Town of Hilton Head Island Regular Design Review Board Meeting

Tuesday, November 22, 2011

UPDATED AGENDA

DESIGN TEAM/DRB COMMENT SHEET

SHEET TITLE
EXTERIOR
ELEVATIONS

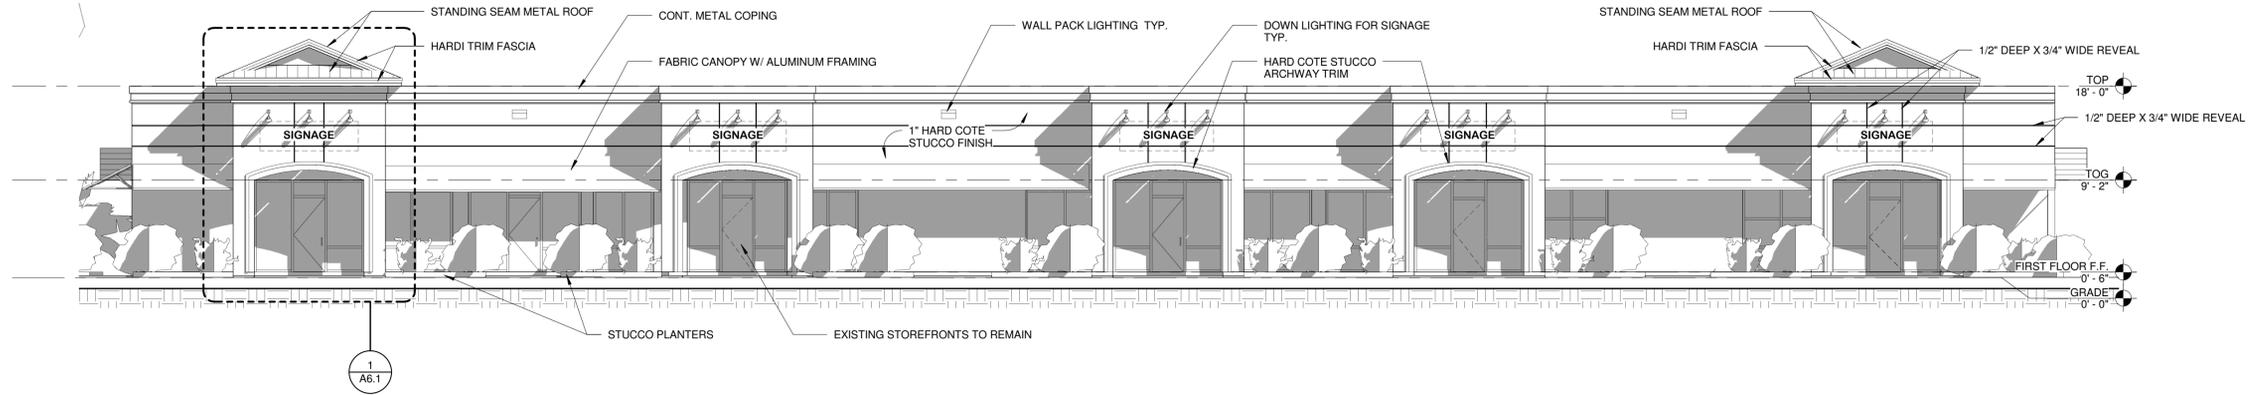
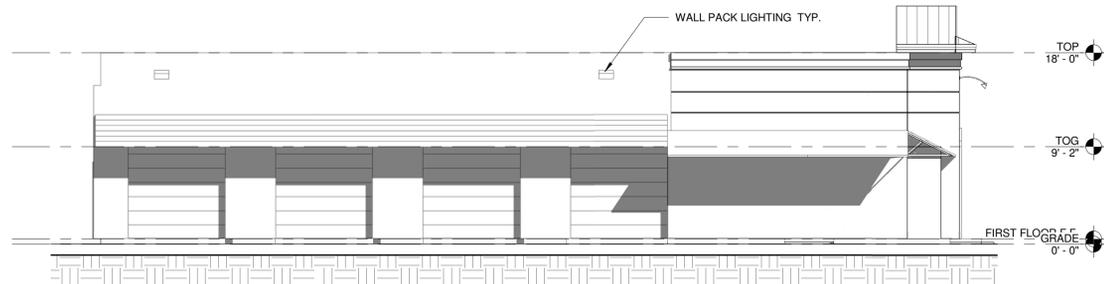
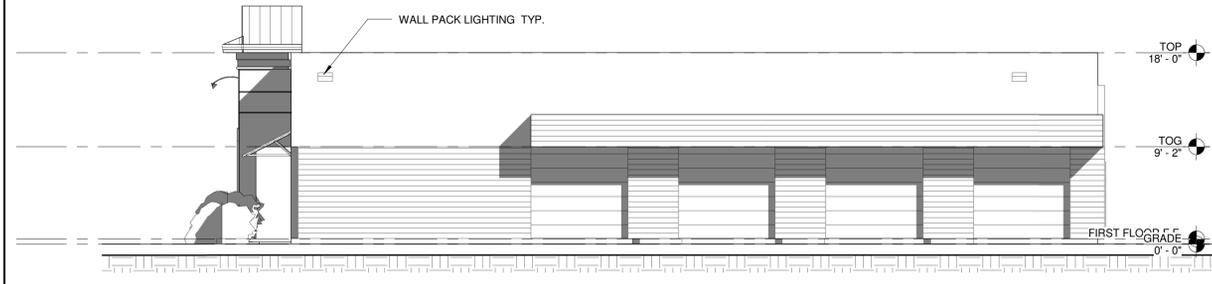
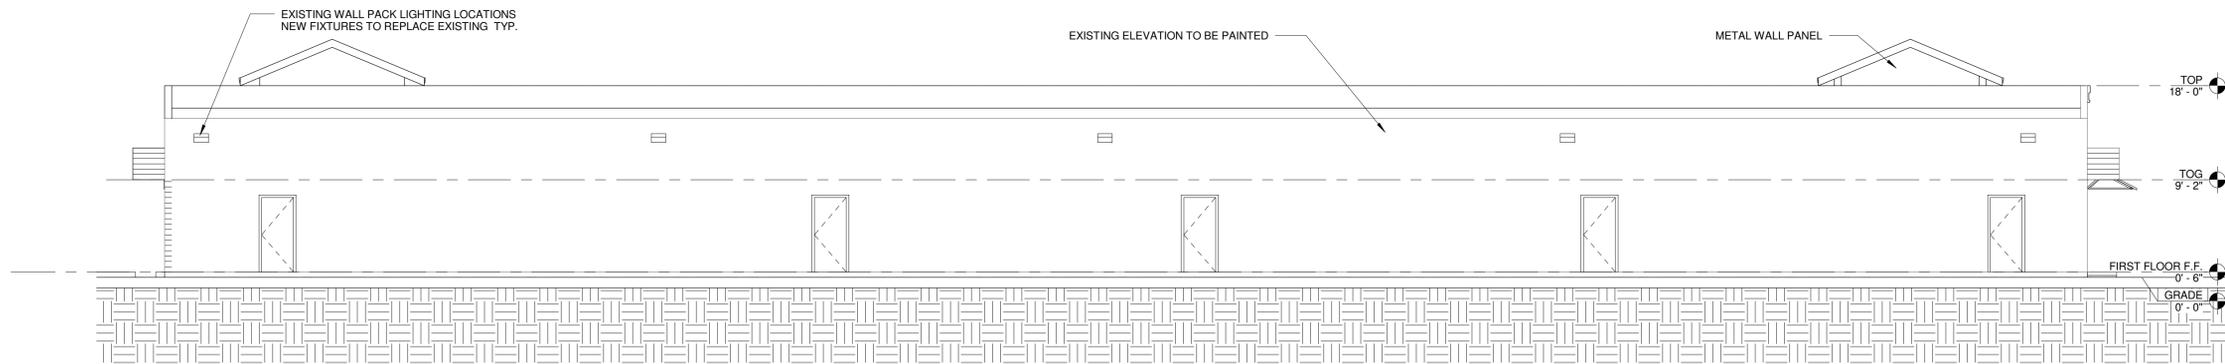
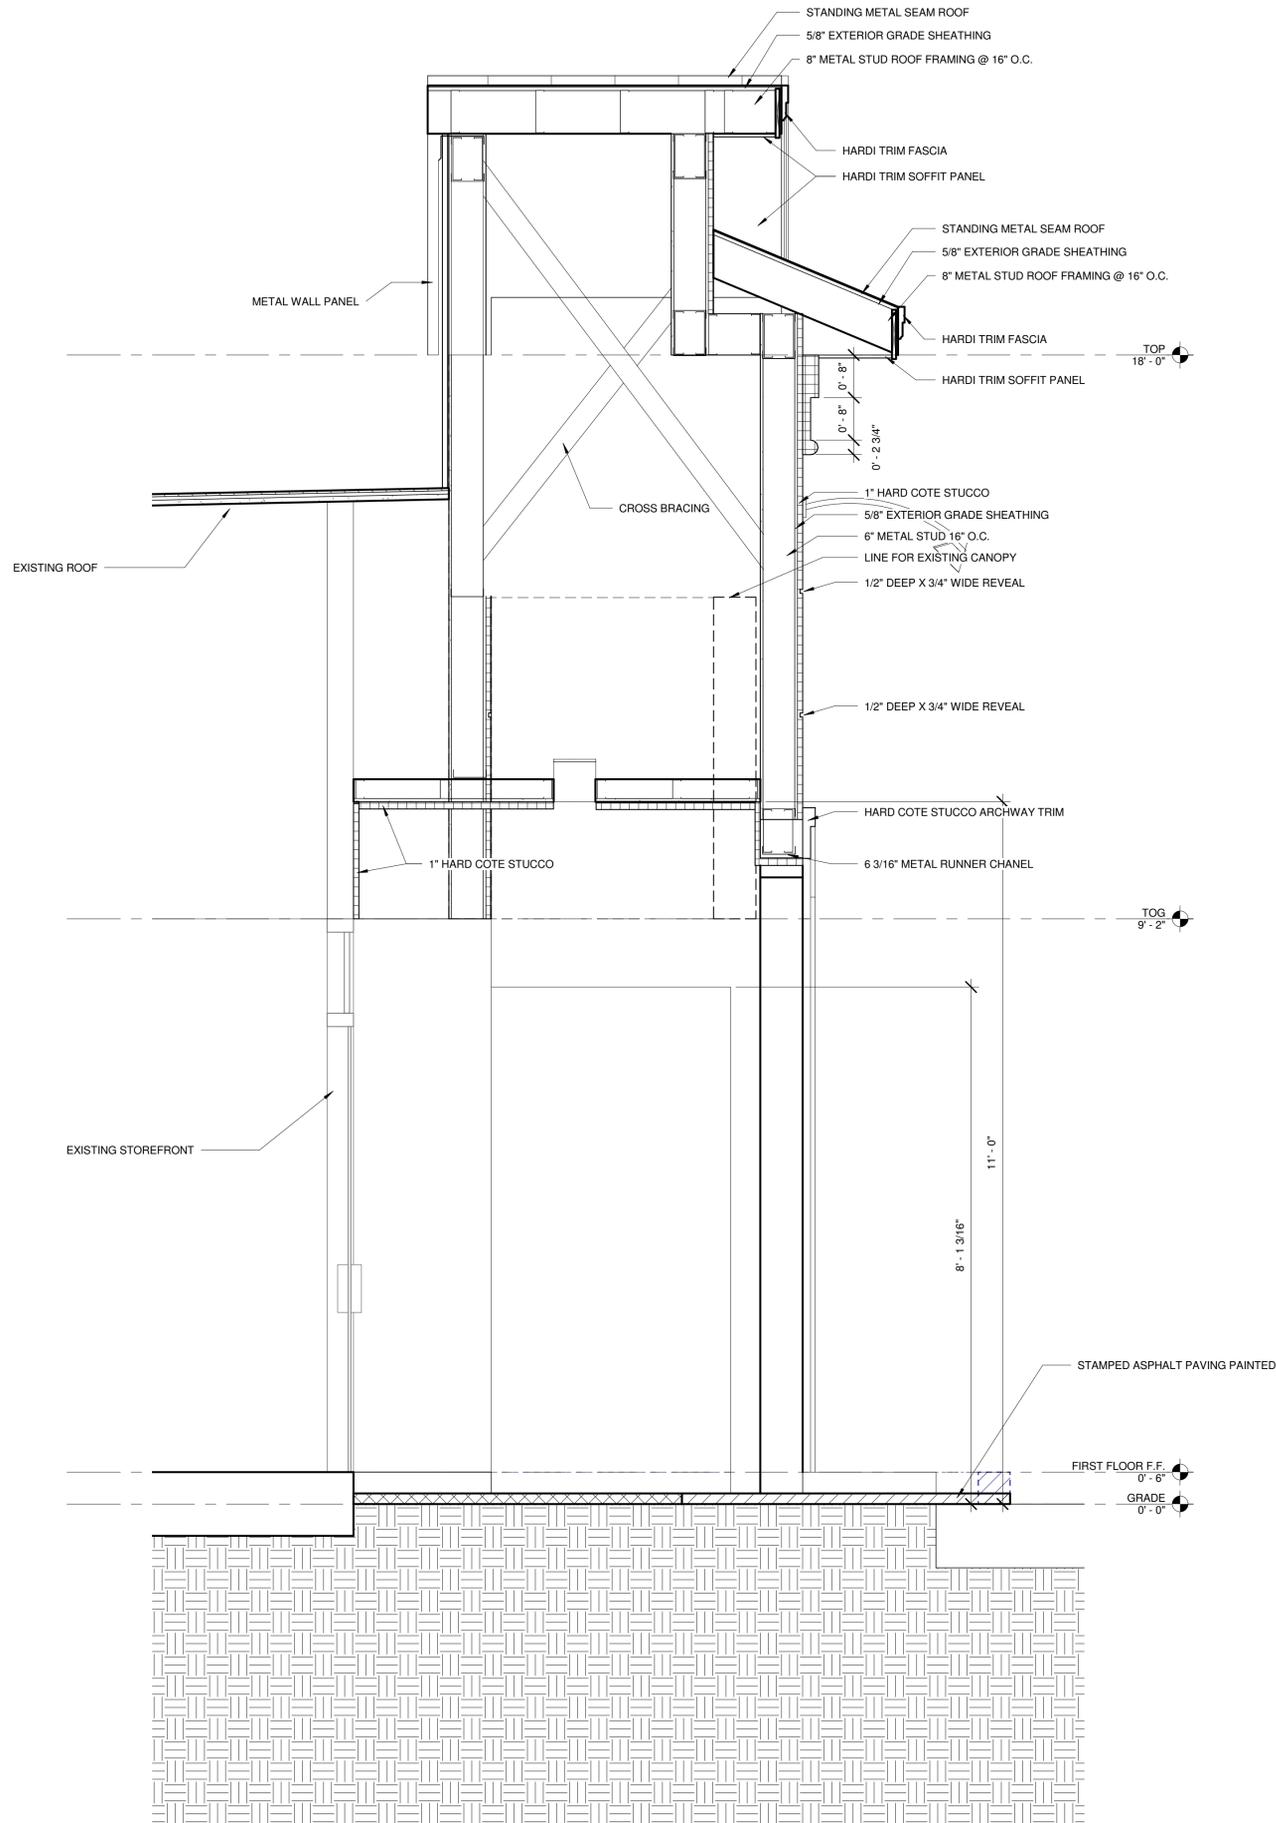
Application addresses the comments from the initial review, relative to the structure. Roof forms have been added and given depth, per the comment from the 11-8 meeting, and wood elements have been incorporated, but solely to the fascia elements on the entry features. More could be incorporated to honor the proportion of wood on the other elevations.

SHEET TITLE
SITE PLAN

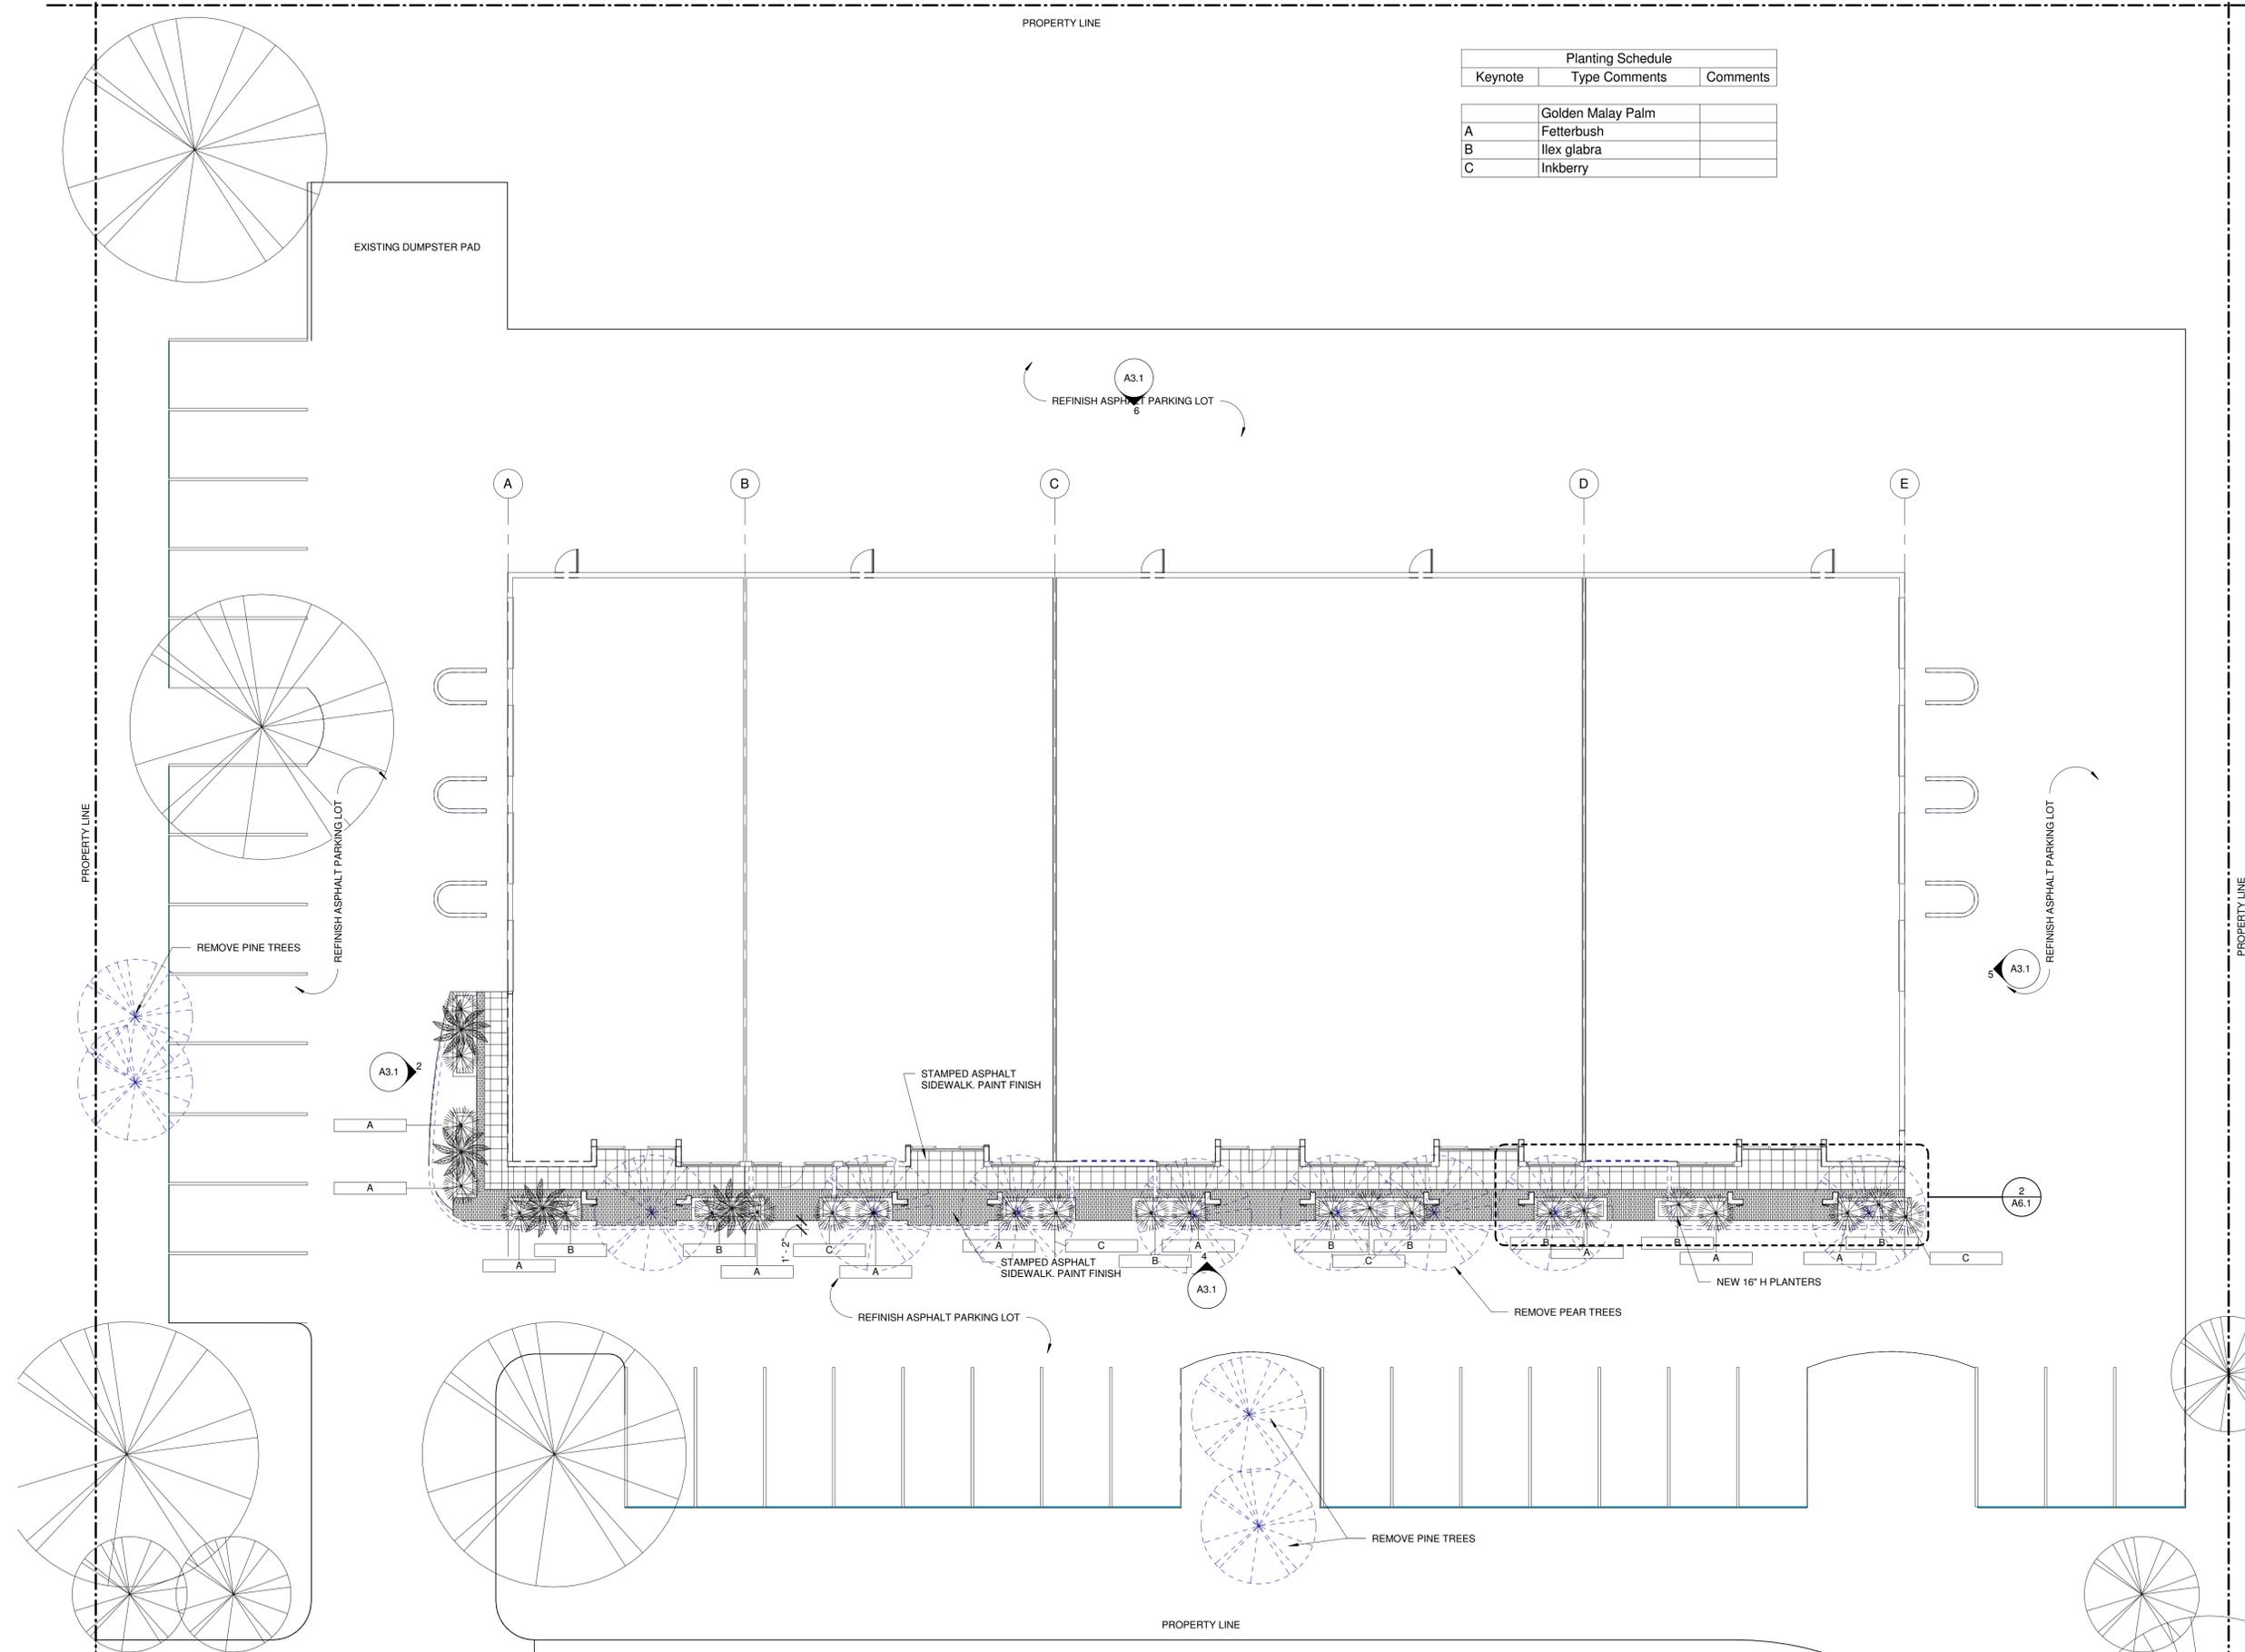
The palmettos appear to have been protected or mitigated, although it isn't clear per the drawing labels.
